### **MILWAUKIE DESIGN AND LANDMARKS COMMITTEE**

**Subject:** Reliable Credit parking lot post-approval review

**File:** DR-14-07

**Design Alternatives**

Wall Option 1 - Facade Wall

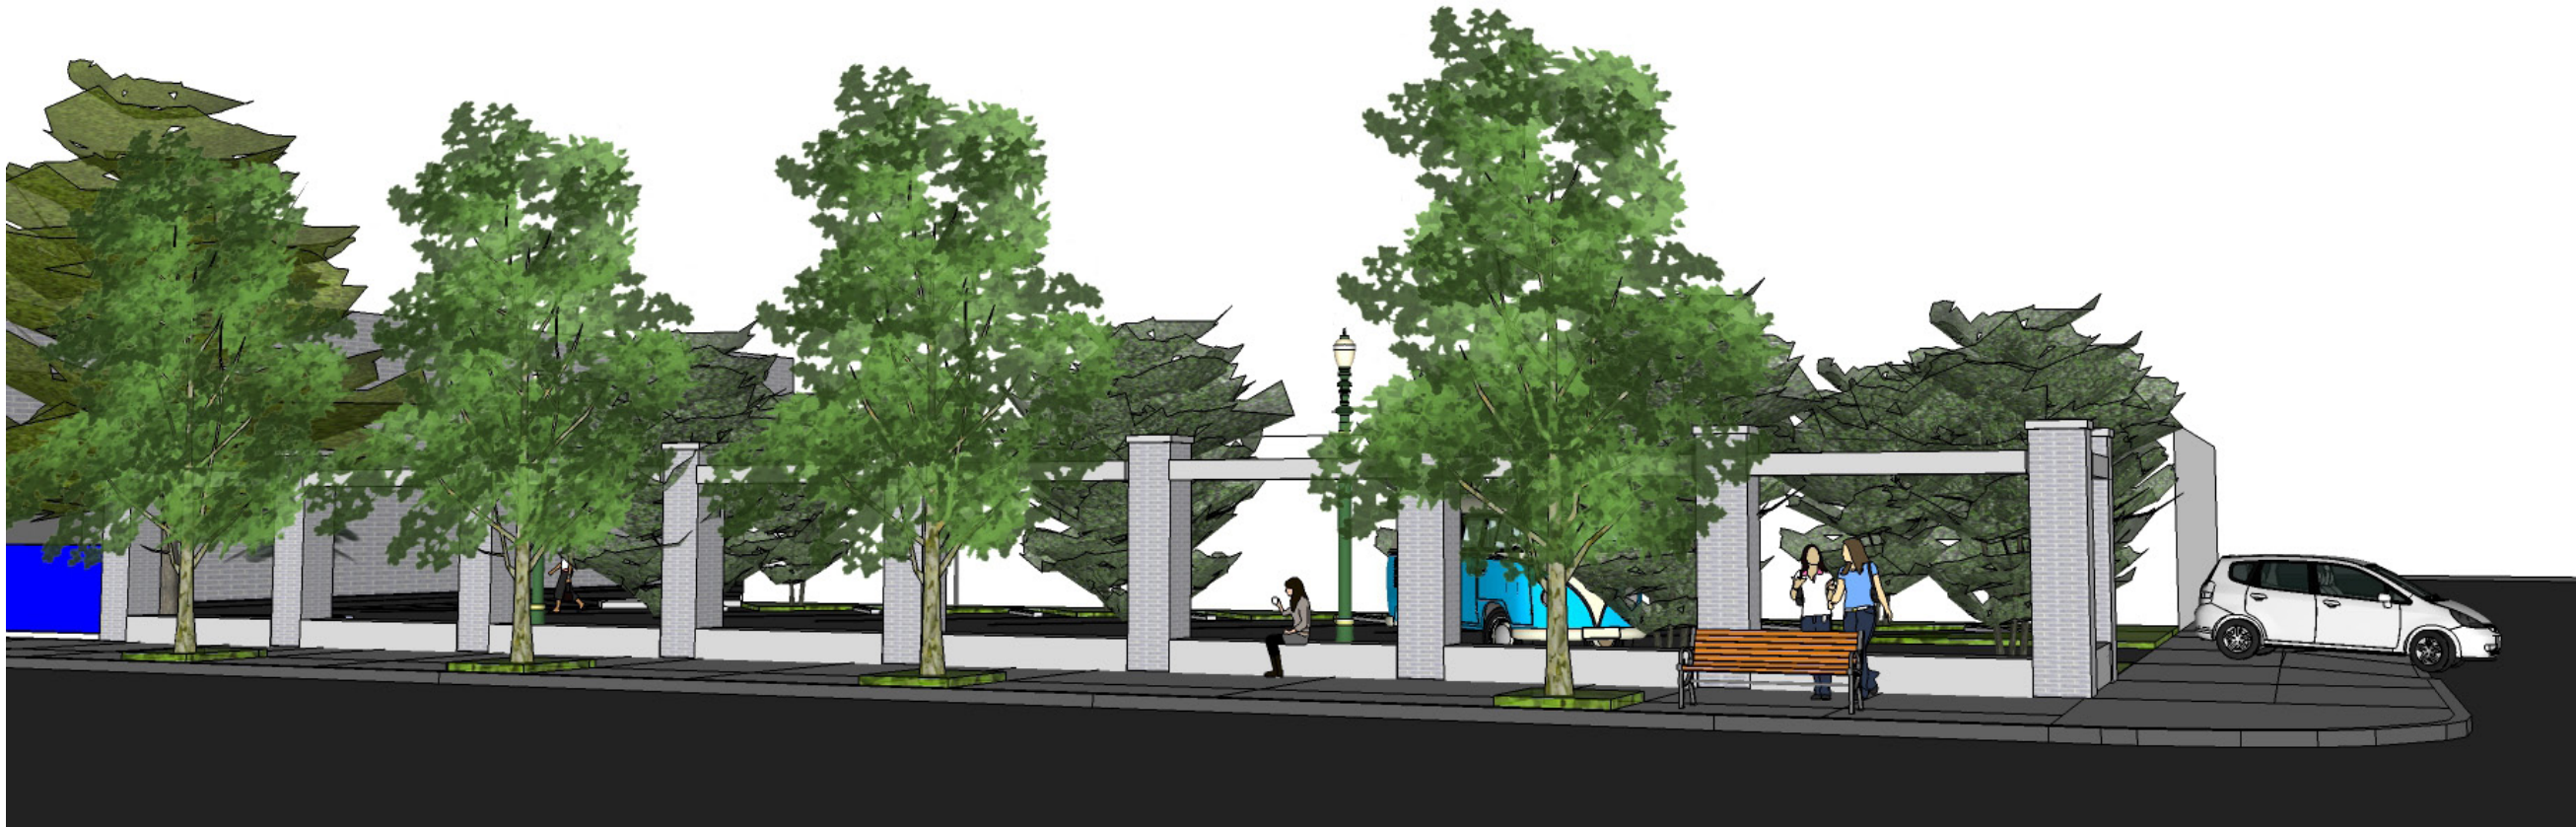
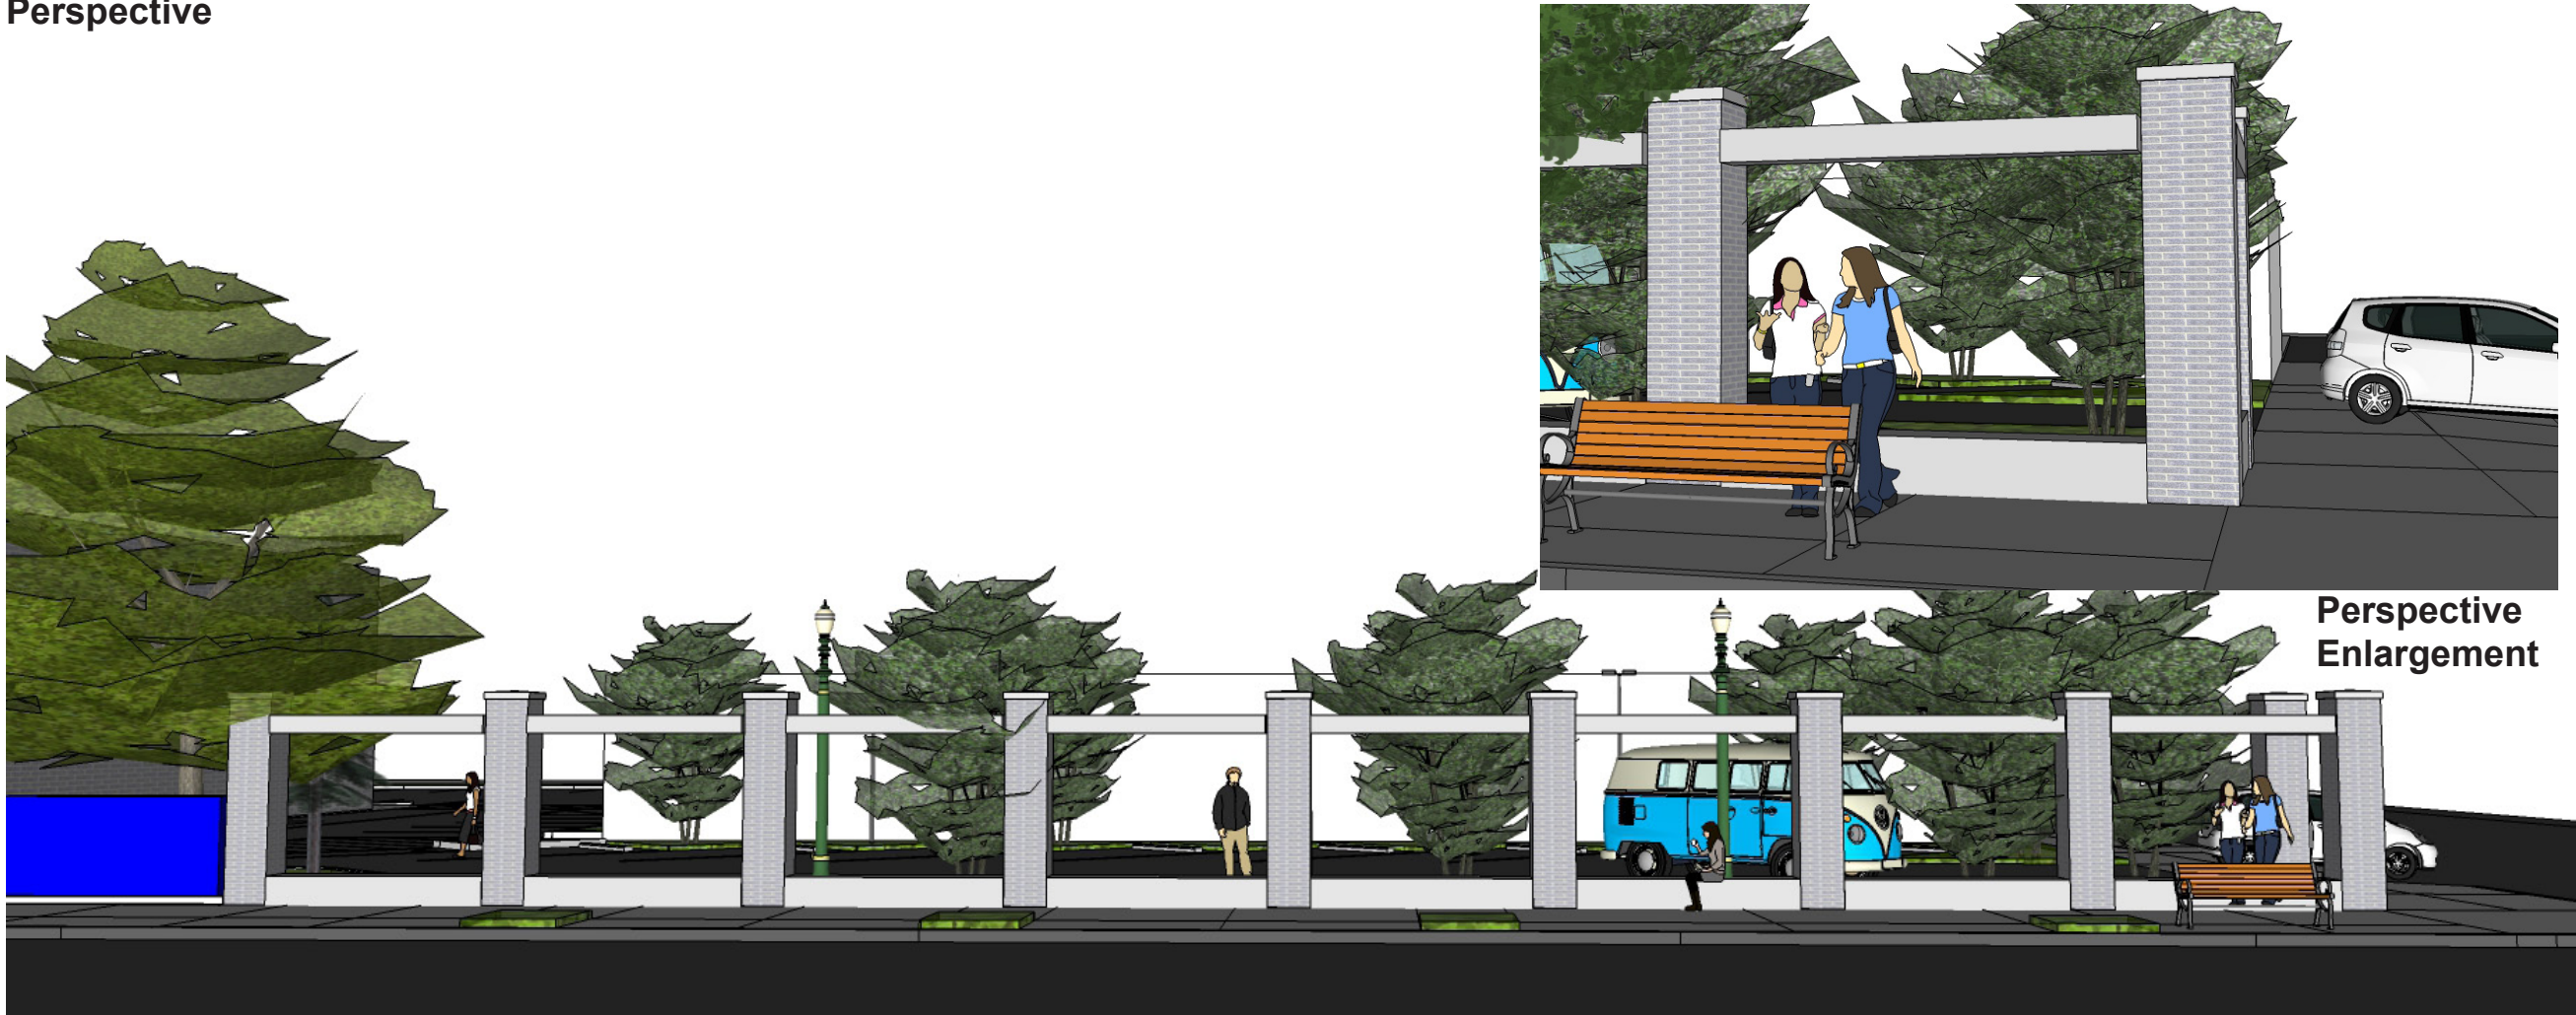
- Option 1: This option includes a wall-like masonry structure which provides a seat wall and masonry columns to support a lintel piece similar to building elements at a door or window. This option is a response to the notion of a building and storefronts adjacent to the sidewalk. This option clearly defines the pedestrian space from the private parking lot. However, while more obviously mimicking a storefront through the use of columns and lintels, the resulting massing is bulky when compared to Options 3 and 4 which use lighter materials and plantings.

Wall Option 2 - Green Screens

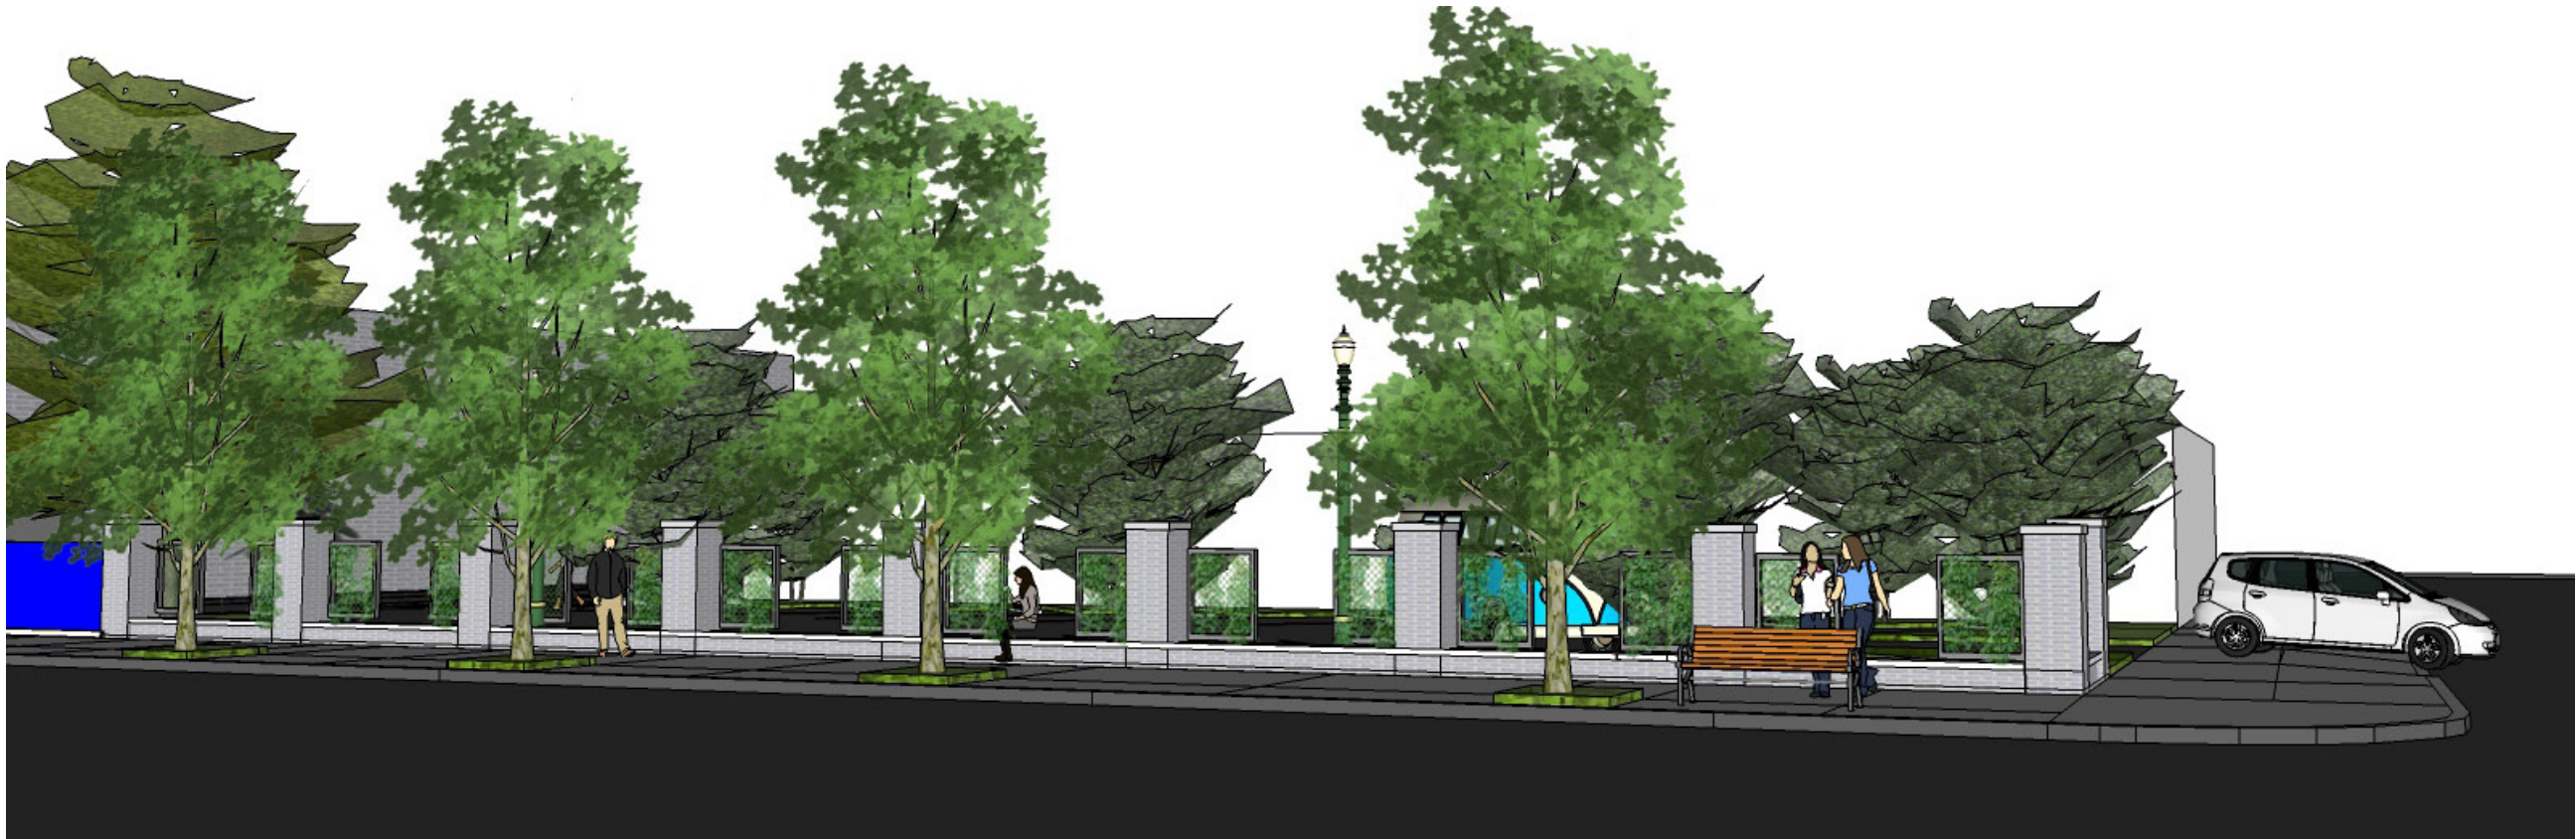
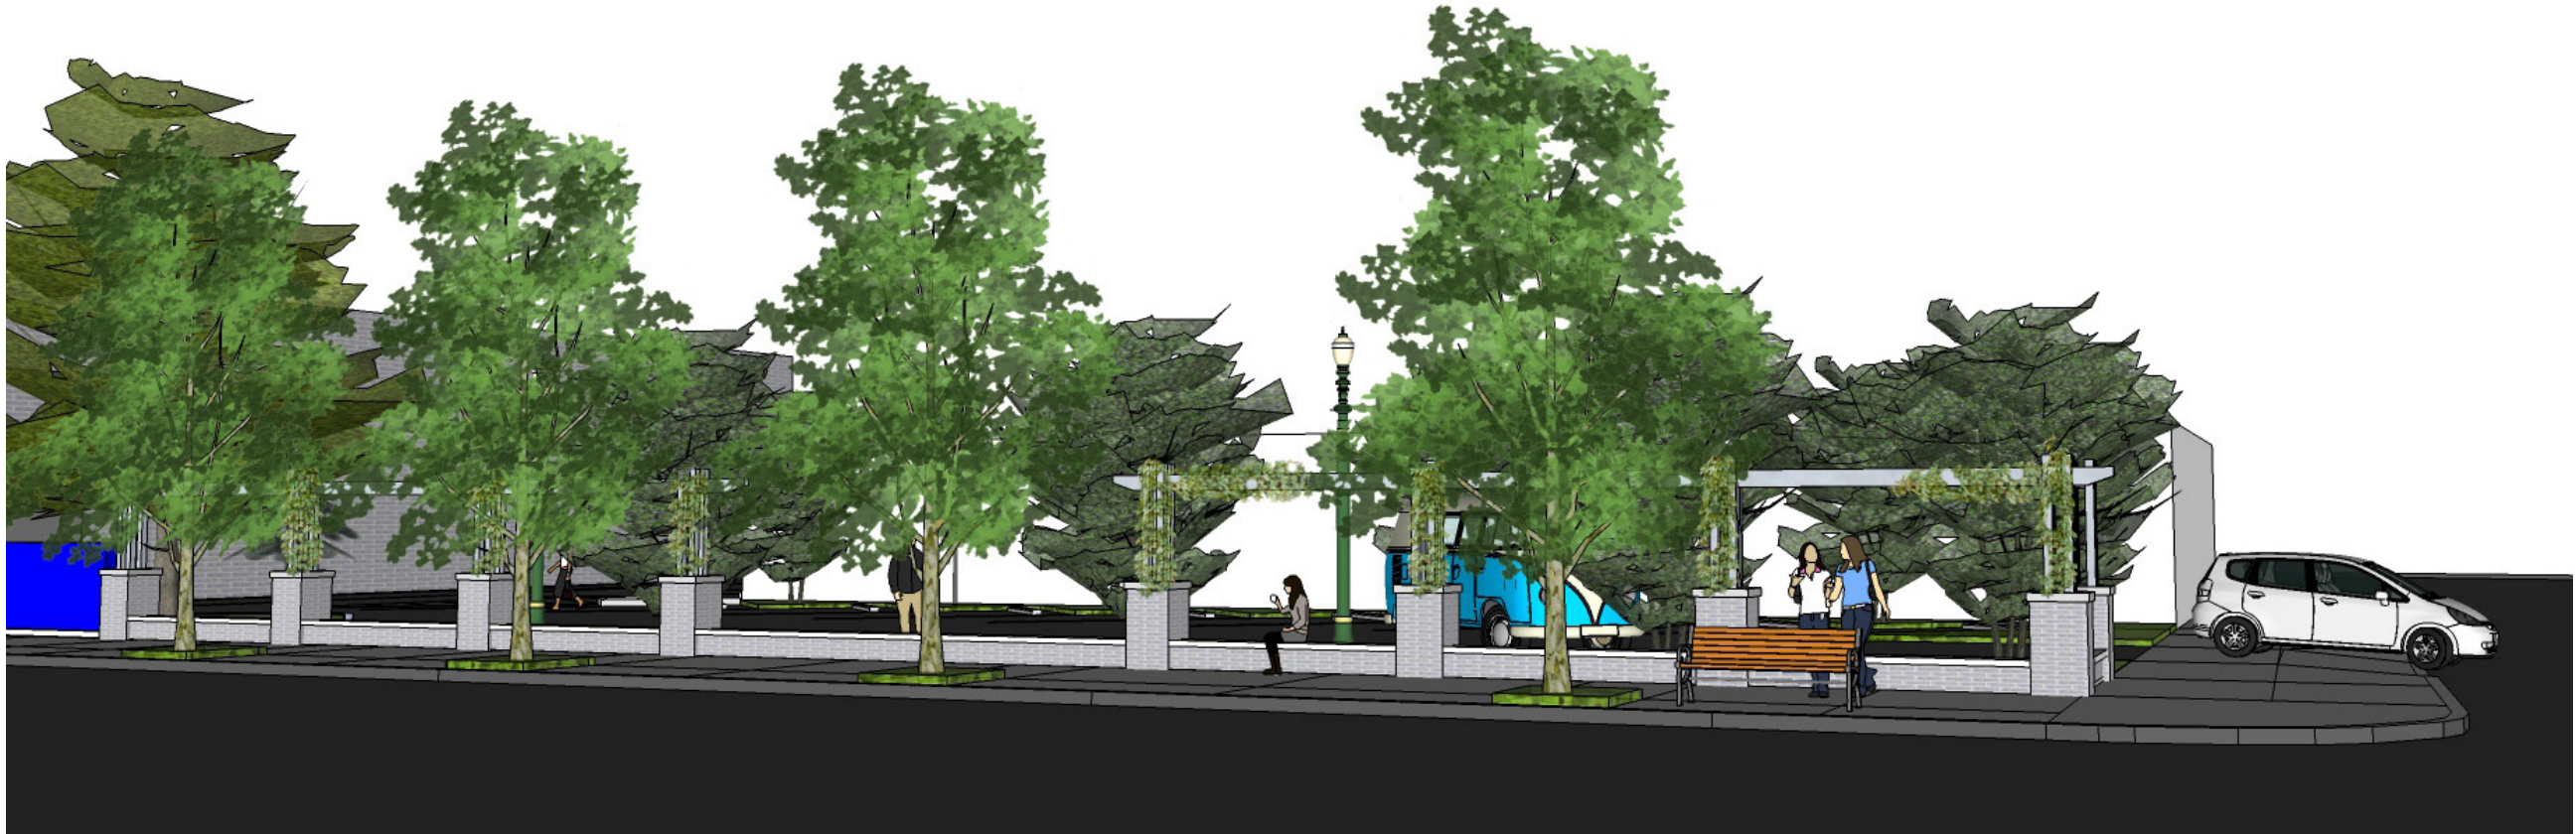
- Option 2: Option 2 is similar to Option 1, but the masonry columns are shorter, there is no lintel element, and "green screens" are attached to the columns to support plantings. Seating remains as part of the design. This option clearly defines the pedestrian space from the private parking lot. However, the use of low columns and "green screens" makes this option is less successful at mimicking a storefront

Wall Option 3 - Trellis

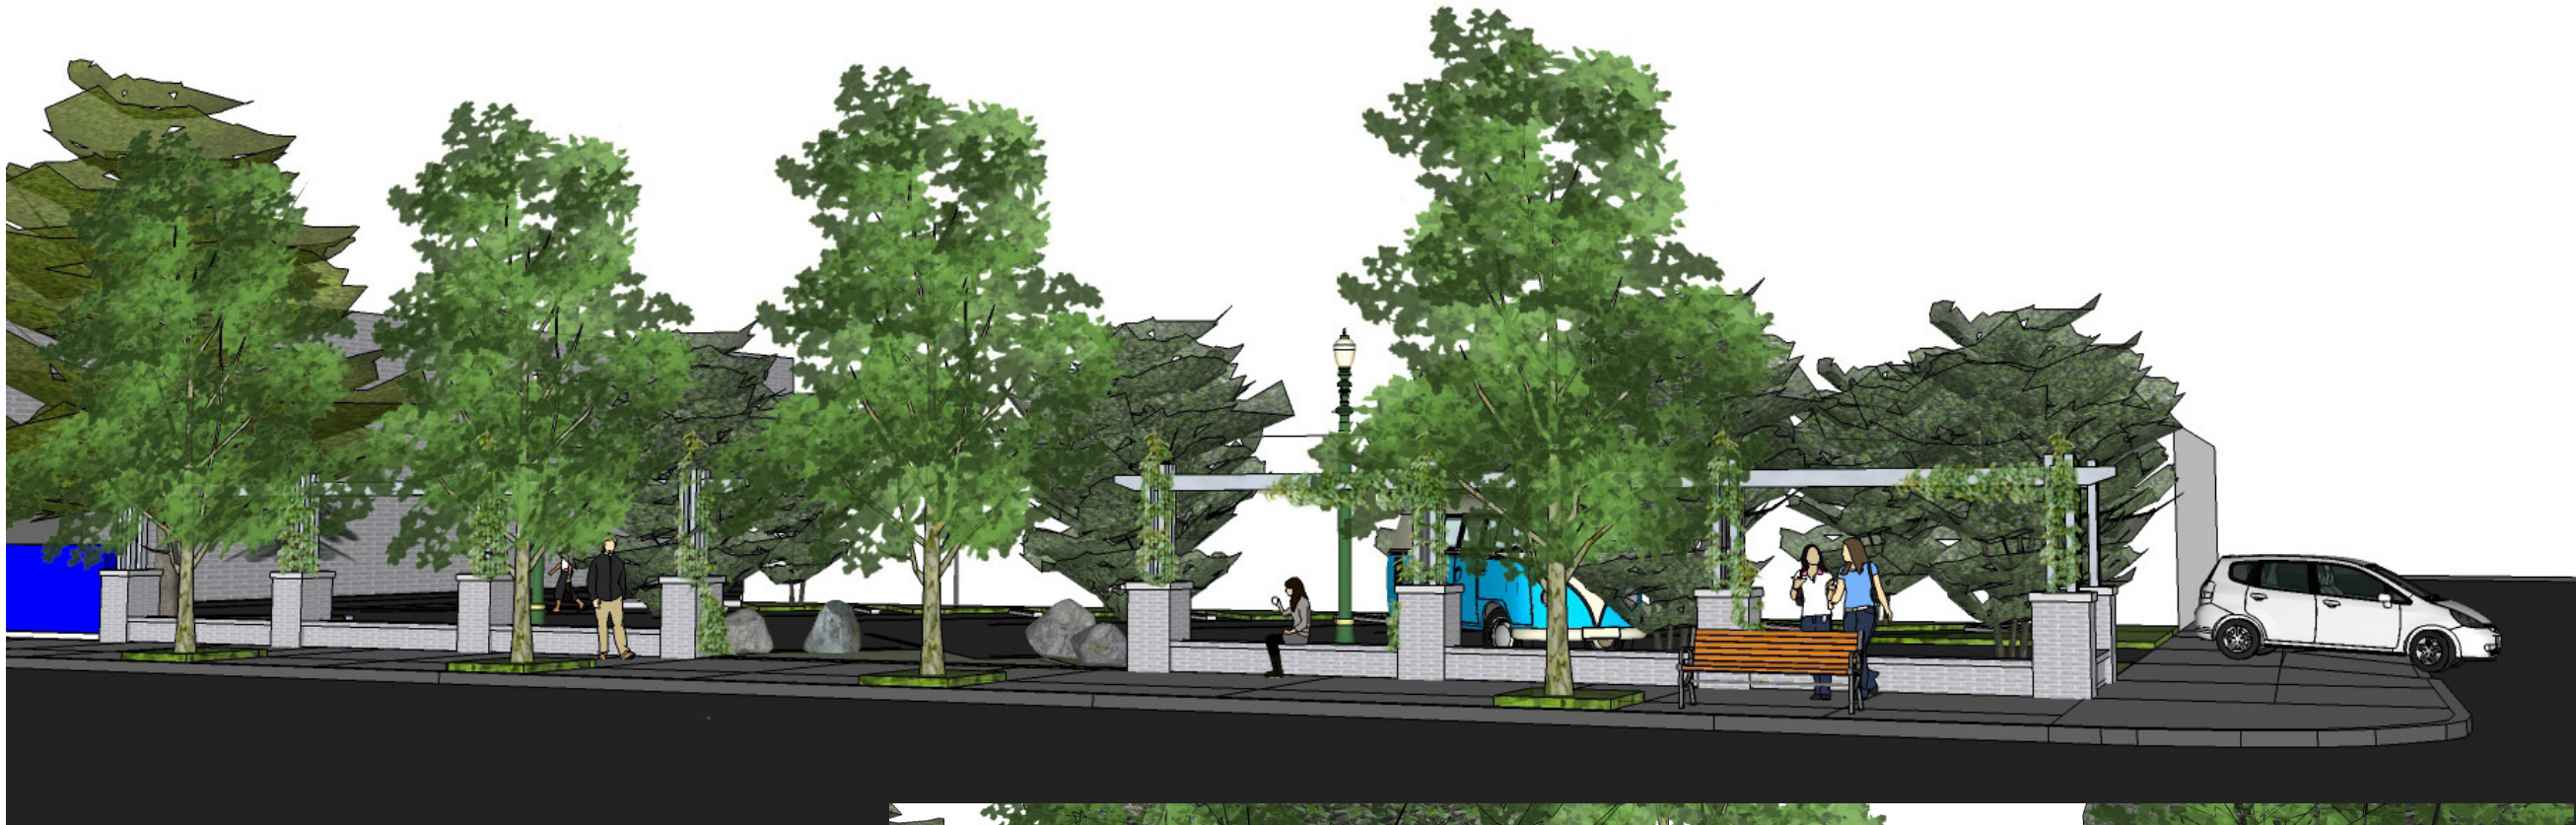
- Option 3: This option includes a seat wall and short masonry columns connected with a metal trellis structure to support plantings both vertically and horizontally. There is a large gap between mid-block to break up the "street wall" structure, but maintains the seat wall. This option clearly defines the pedestrian space from the private parking lot. It also mimics a storefront through the representation of storefront openings with the columns and trellis structure.
